ADDENDUM #1

A. Project Number: 15-STA-512
B. Project Title: Plaza Upgrade
C. Project Location: 701 W. Riverside Ave, Spokane, WA
D. Owner: Spokane Transit Authority

ADDENDUM # 1

DATE	DRAWN	DWG. NO.	JOB NO.	REF. SHT.
08/13/2015	KVP	S-01	15-STA-512	S-111

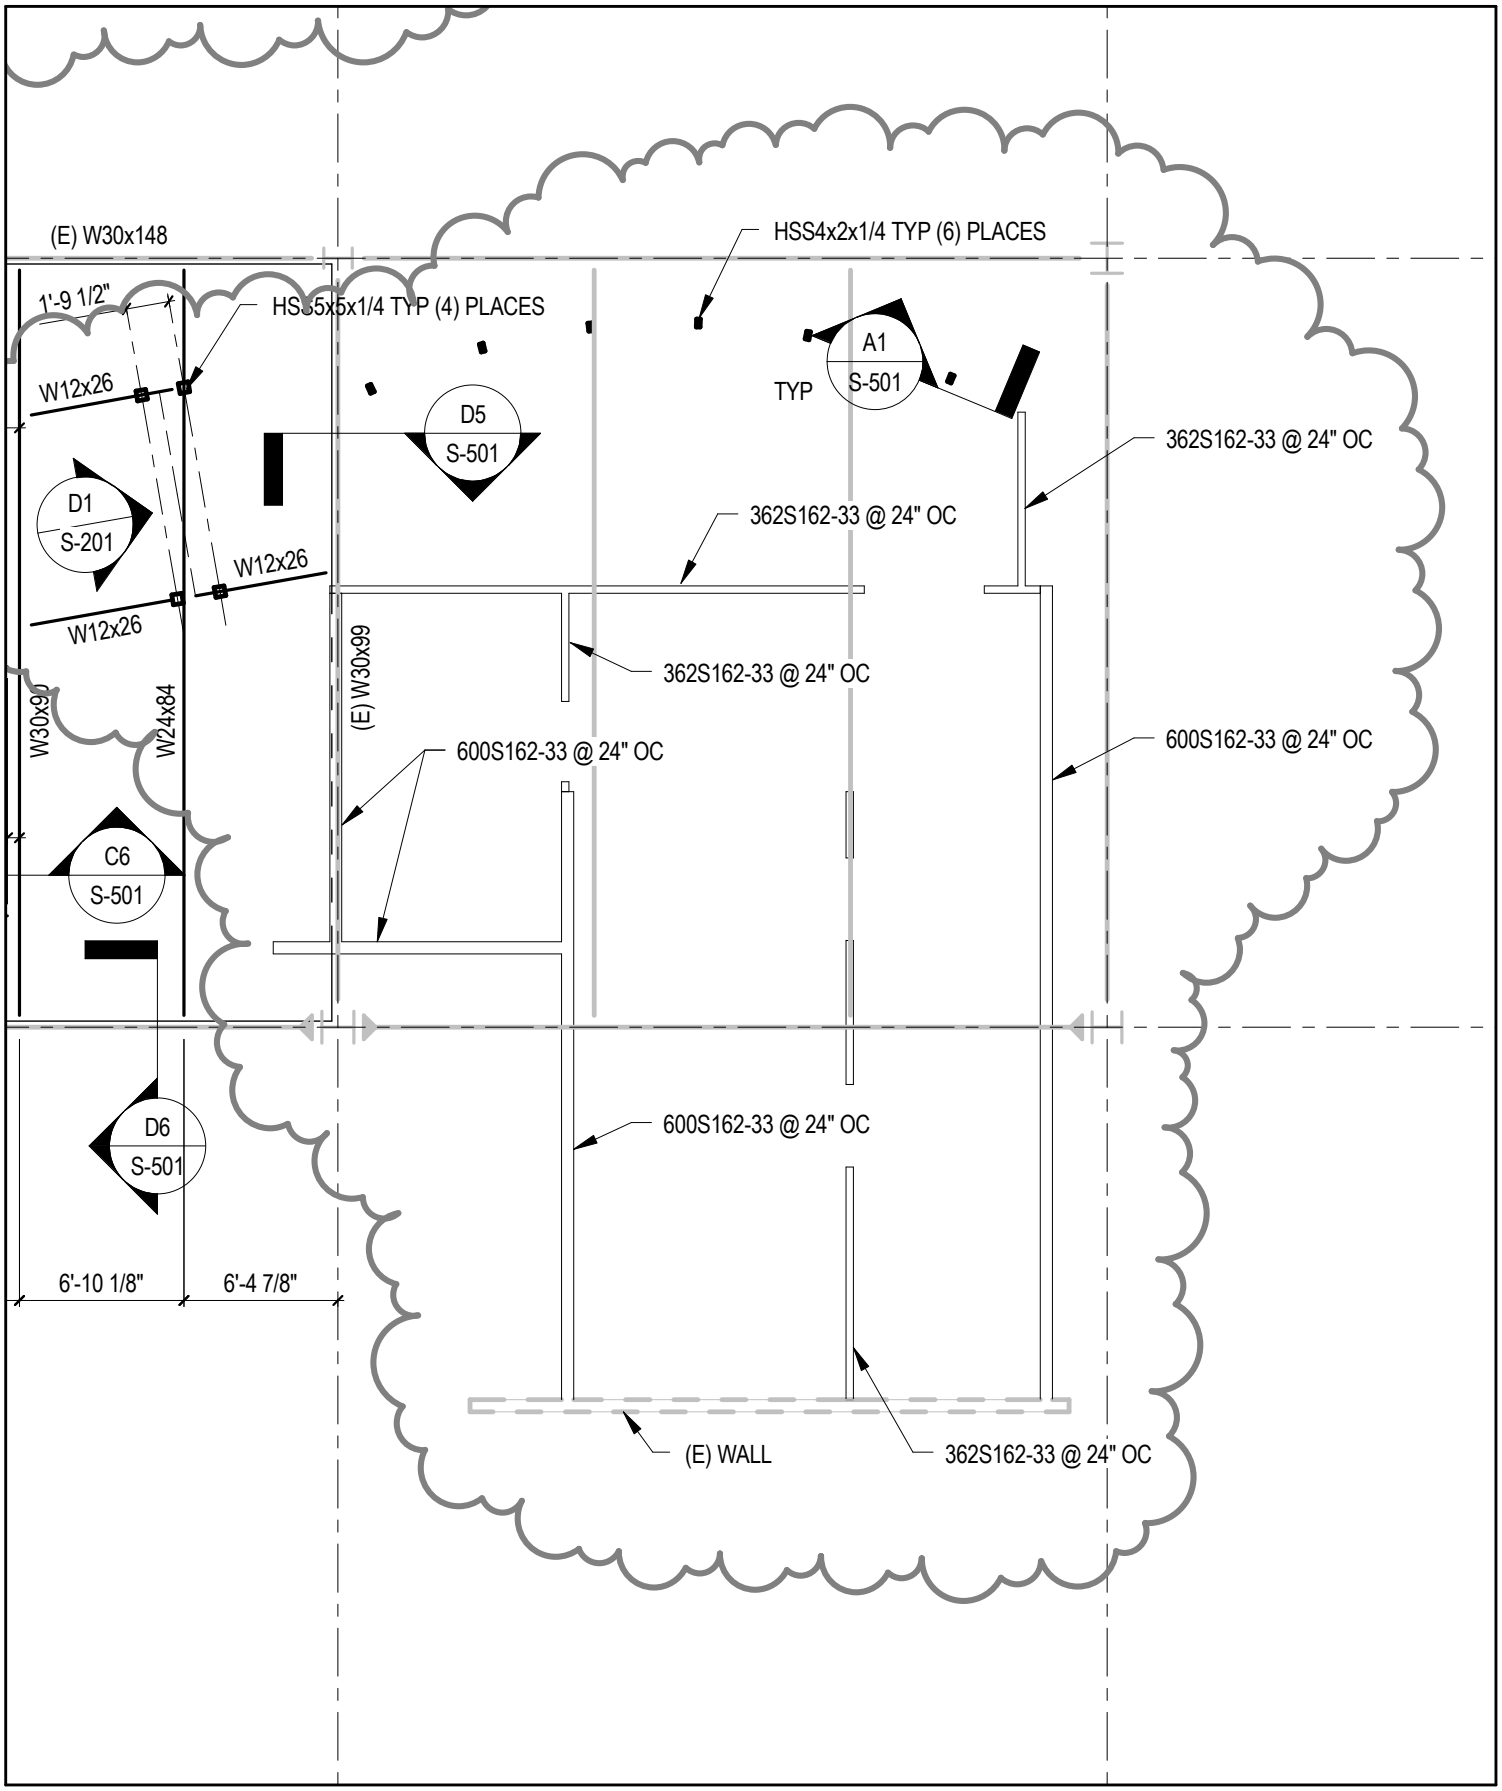
31.	Sheet S-111; Sheet S-501,detail A2 & A3	ADD details for Male & Female Cougar Statues; reference sketches S-02 & S-11
32.	Sheet S-111; Sheet S-121, detail B6; Sheet S-201, detail B6, A3, A5 & A6; Sheet S-501, detail A1, A5 & A6	ADD framing and details for Customer Service Area; reference sketches S-01, S-03, S-06, S-07, S-08, S-09, S-10, & S-12

33.	Sheet S-111	W12x26 was W12x22, typ (3) places at Clock Tower; reference sketch S-01
34.	Sheet S-131	ADD note “All condensing unit piping to be core drilled.”

DESCRIPTION
ADDED FRAMING AT CUSTOMER SERVICE AREA

DATE	DRAWN	DWG. NO.	JOB NO.	REF. SHT.
08/13/2015	KVP	S-02	15-STA-512	S-111

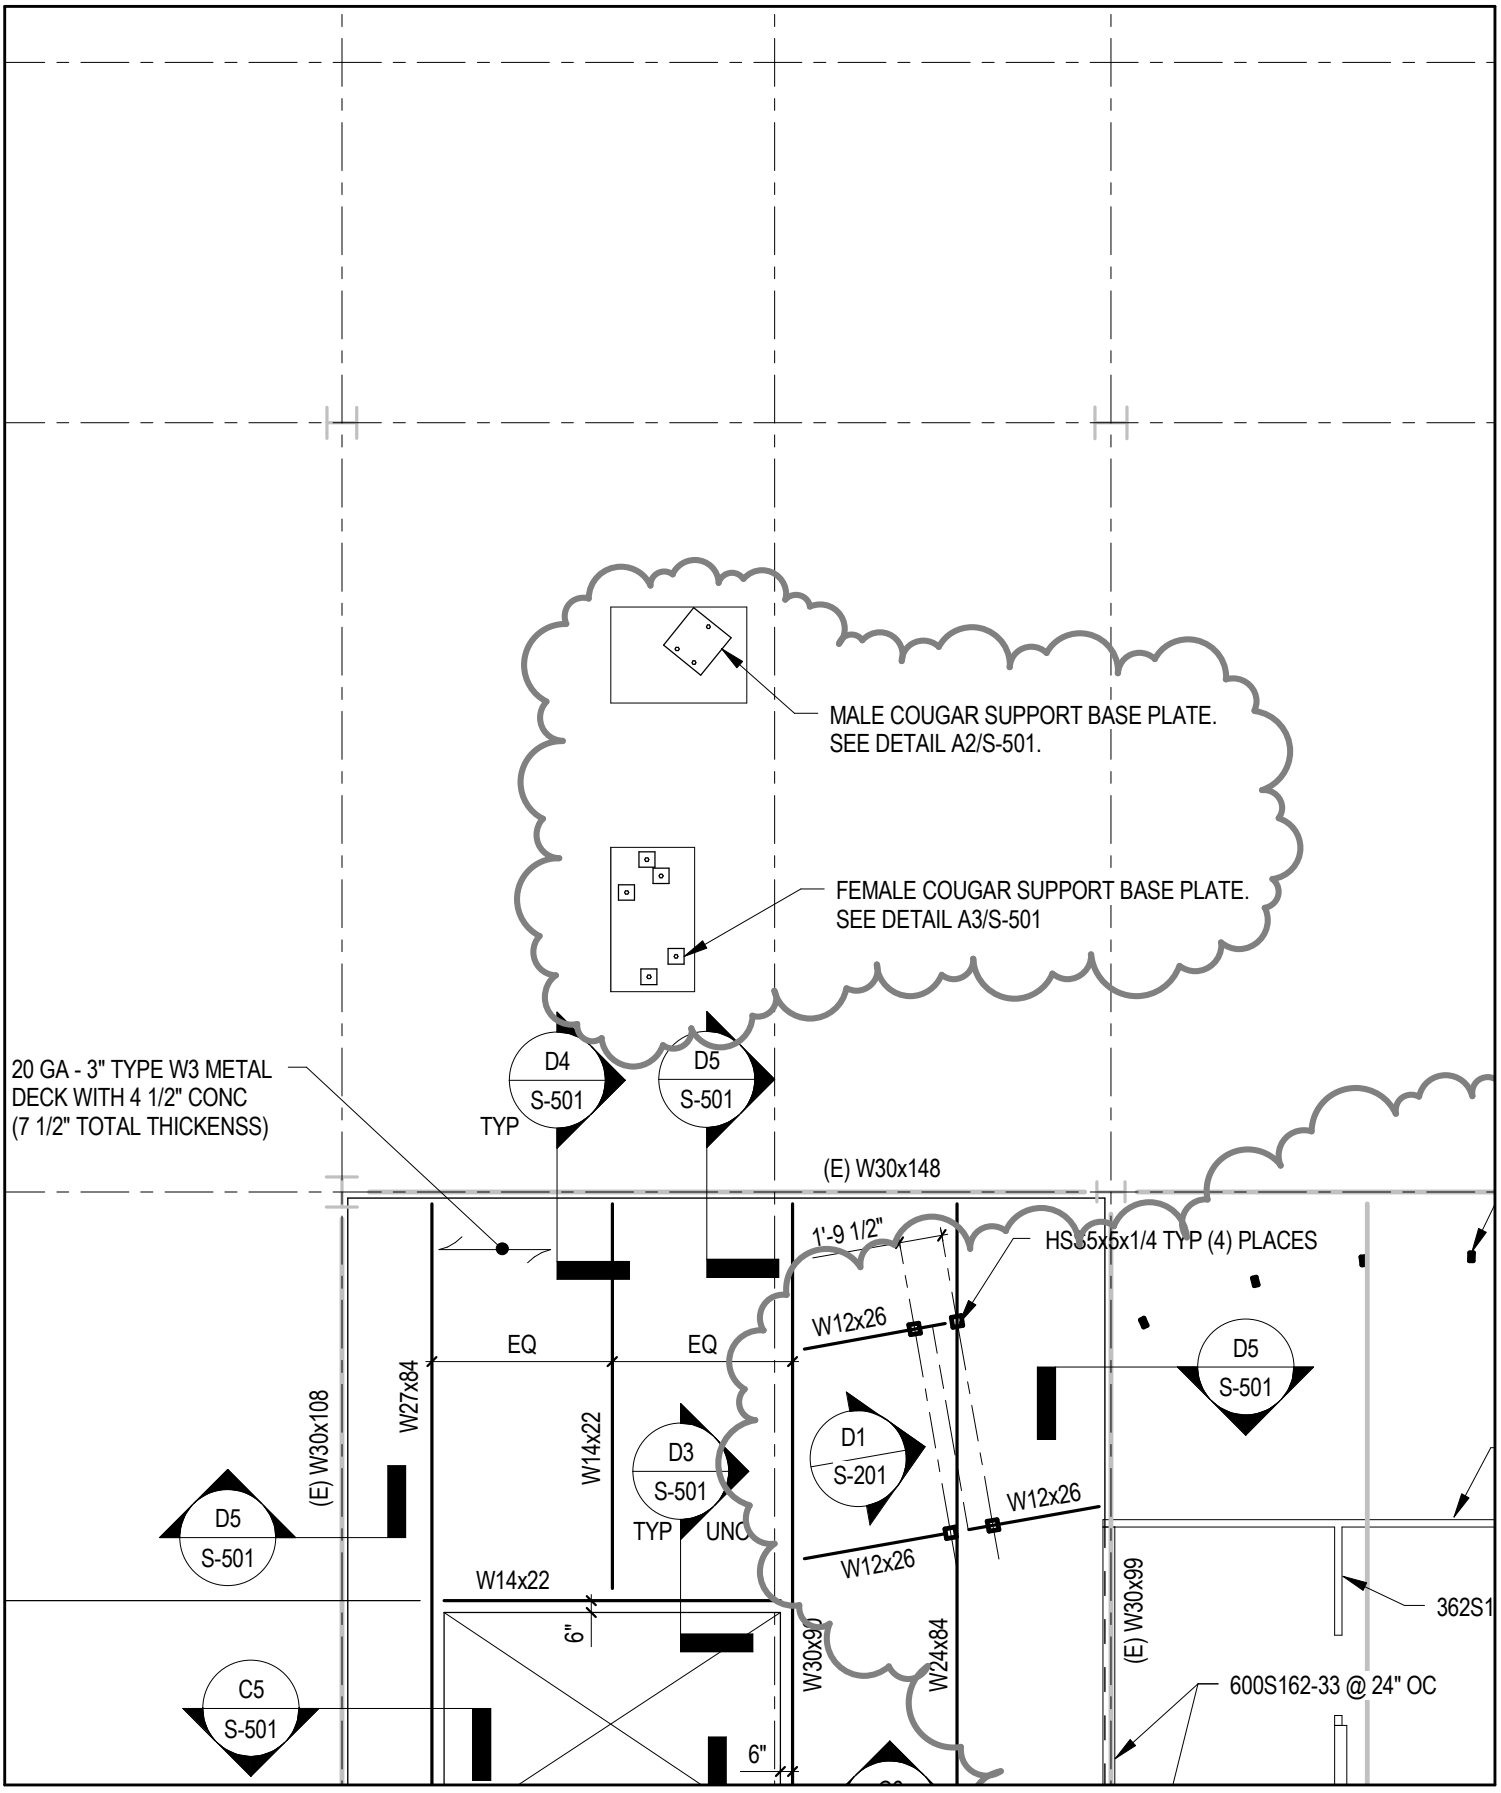
DESCRIPTION
ADDED STATUE SUPPORT FRAMING

DATE	DRAWN	DWG. NO.	JOB NO.	REF. SHT.
08/13/2015	KVP	S-03	15-STA-512	S-121

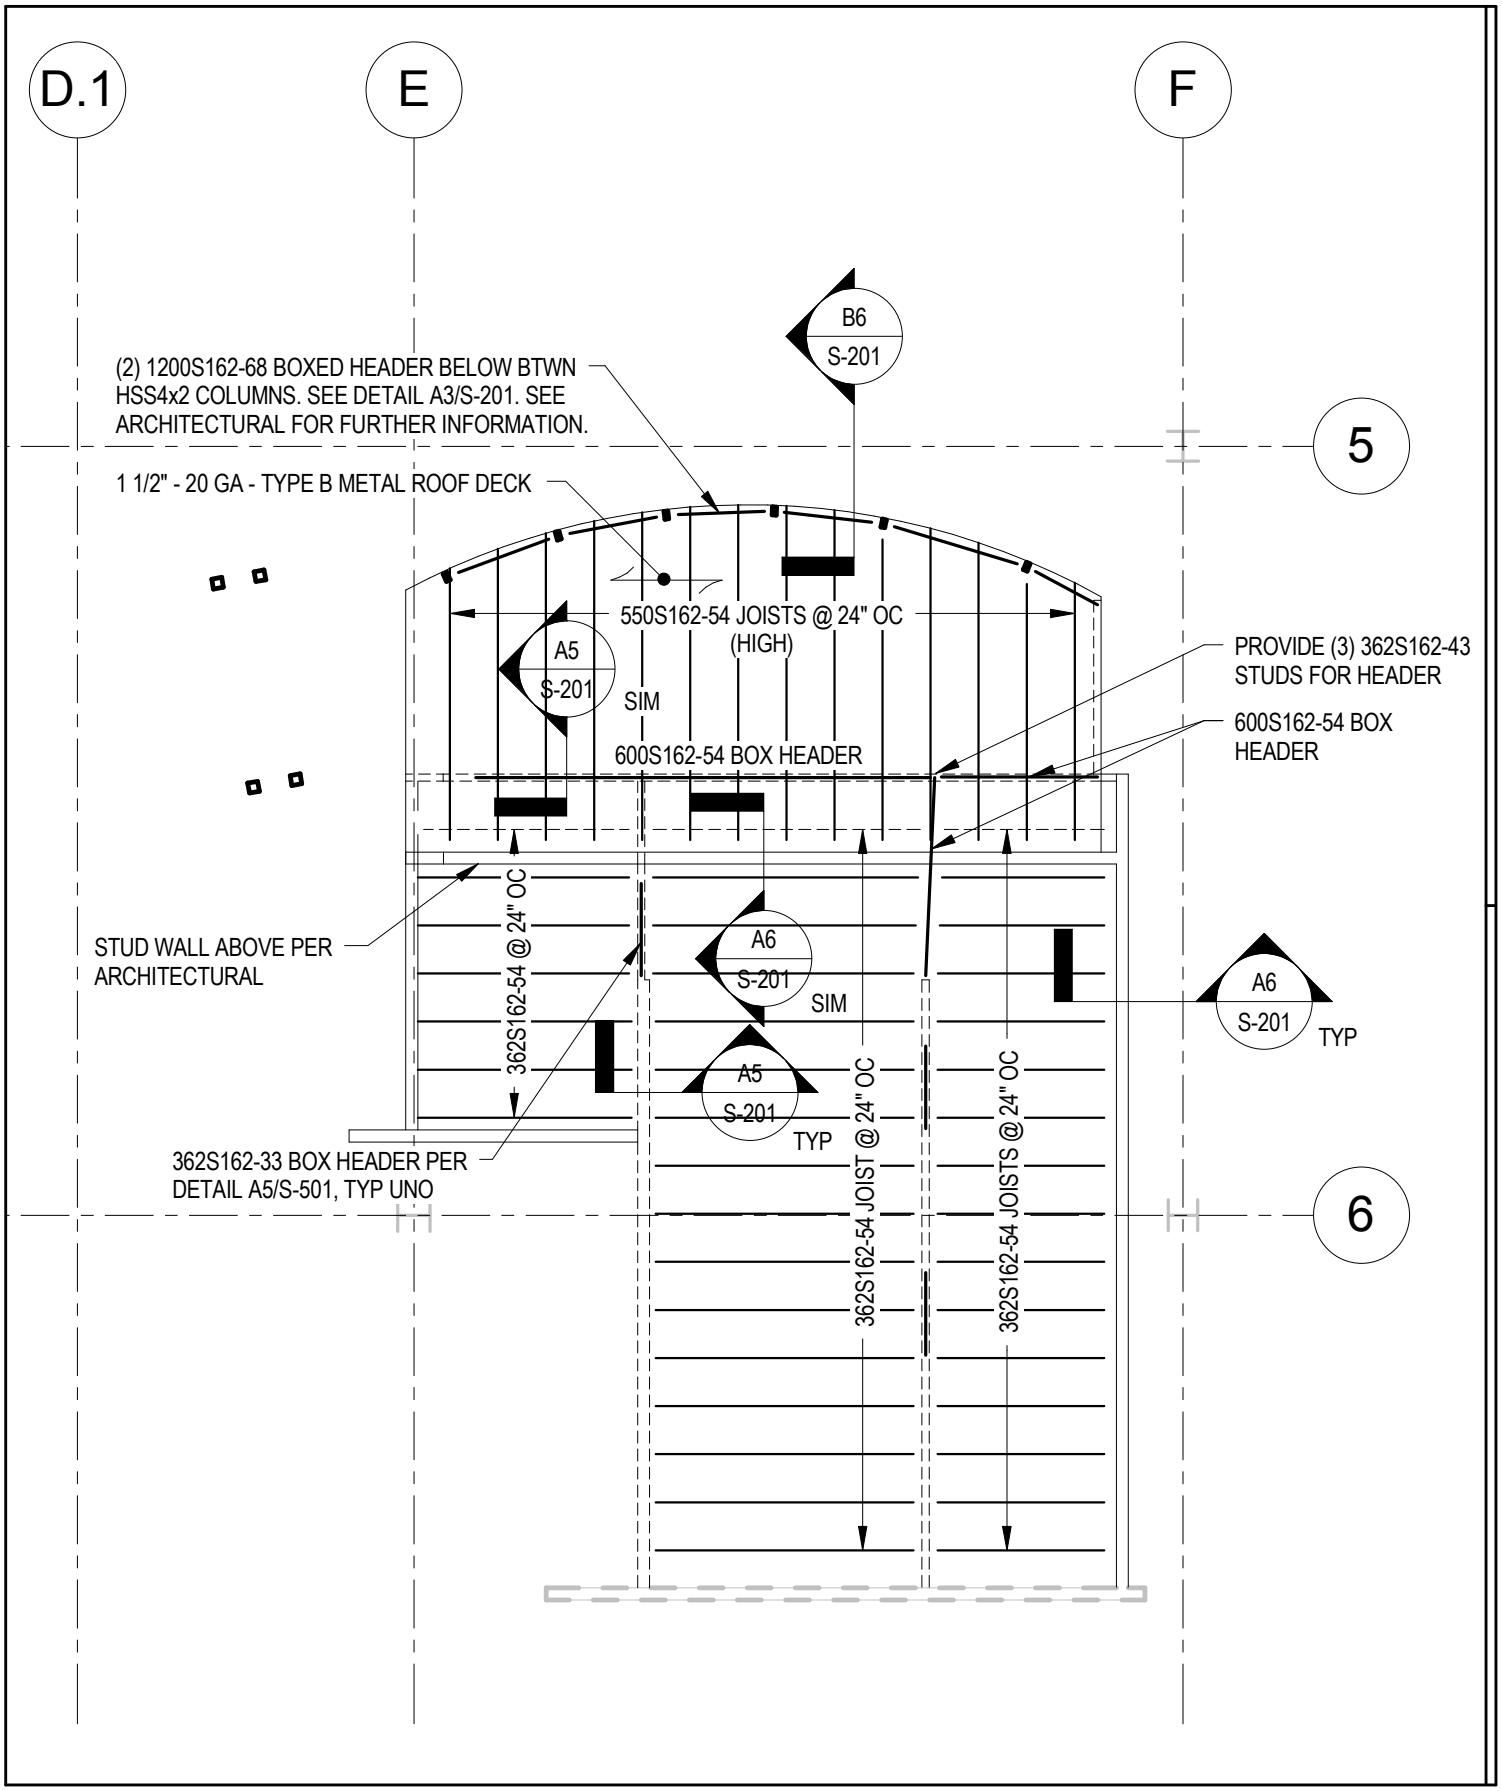
DESCRIPTION
CUSTOMER SERVICE ROOF FRAMING PLAN

DATE	DRAWN	DWG. NO.	JOB NO.	REF. SHT.
08/13/2015	KVP	S-04	15-STA-512	S-201

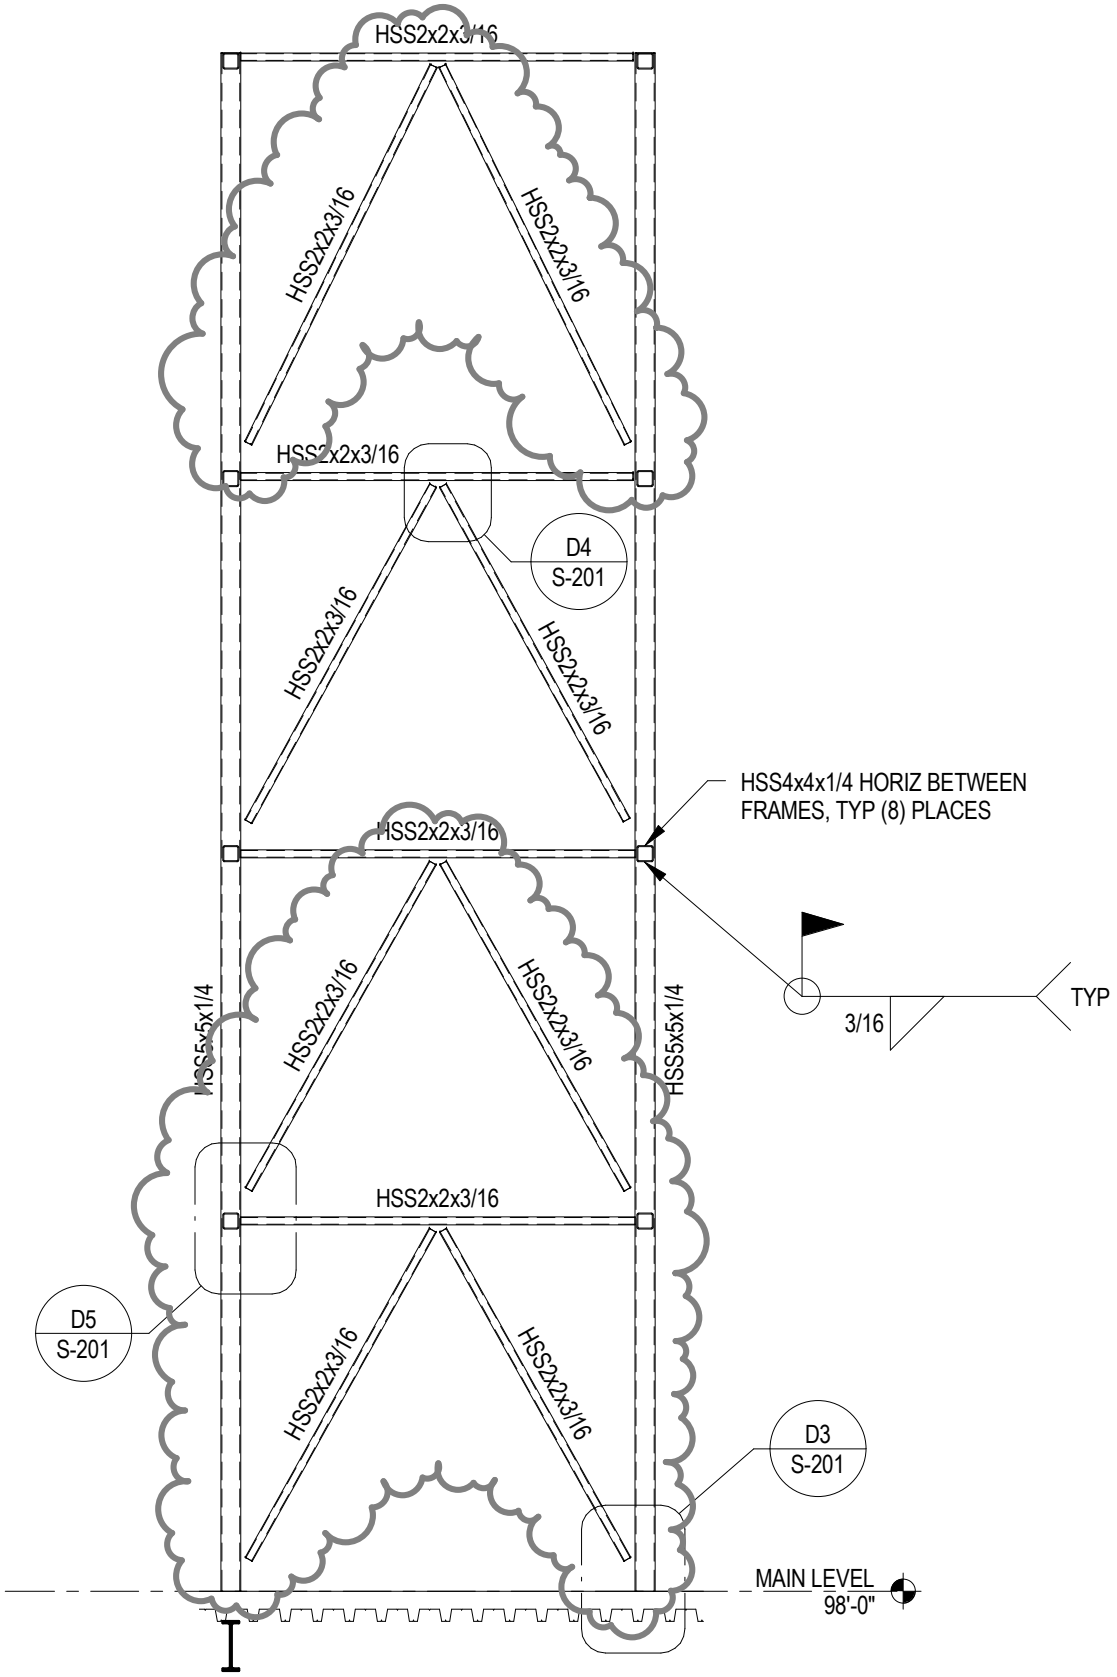
35.	Sheet S-201, detail D1, D5, & D6	REVISE Clock Tower framing to chevron configuration at all bays; reference sketches S-04 & S-05
36.	Sheet E-102	Changed luminaire type between clouds to RJj1, refer to sketch E-01

DESCRIPTION
REVISED BRACE FRAMING

D5 DIAGONAL BRACE CONNECTION AT BEAM/COLUMN

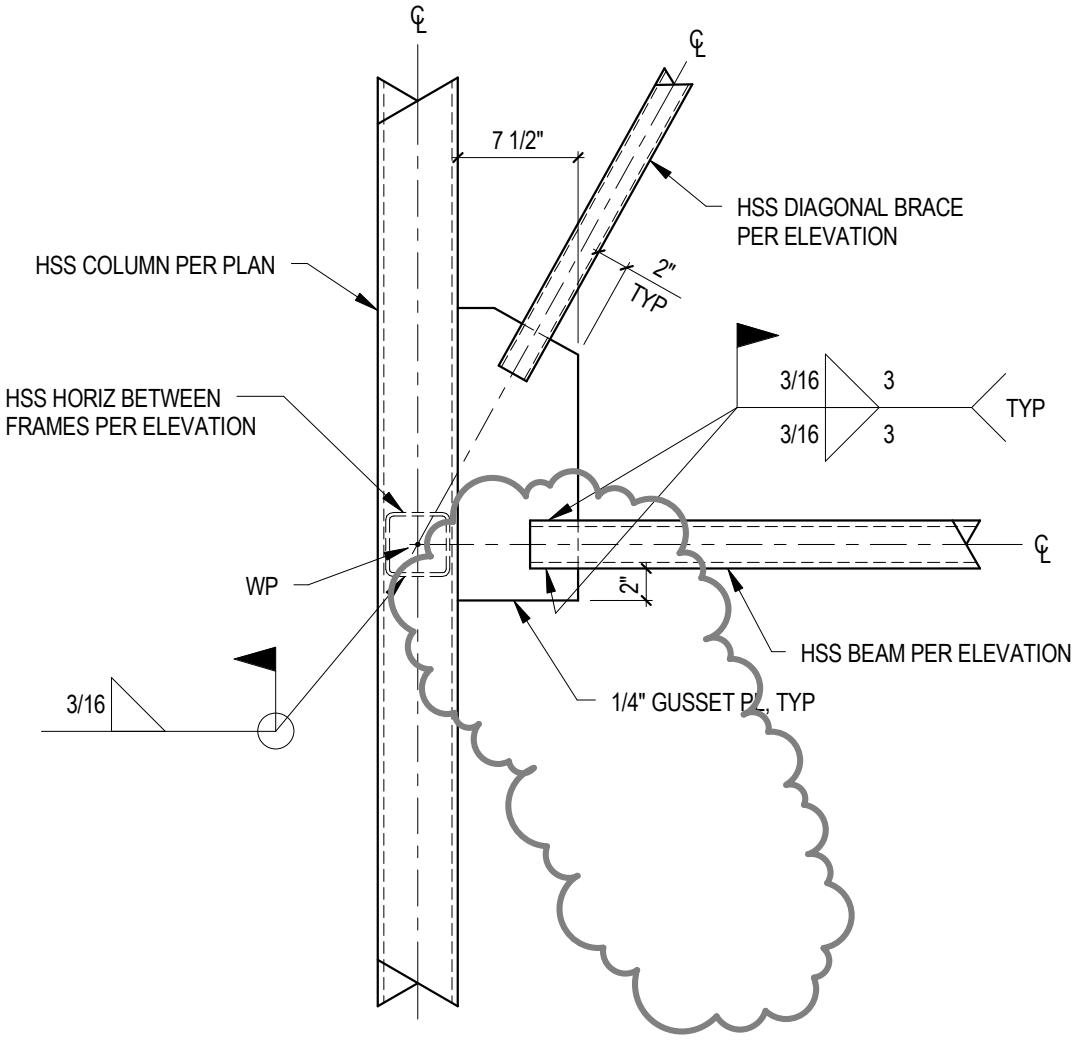
DESCRIPTION
REVISED BRACE FRAMING
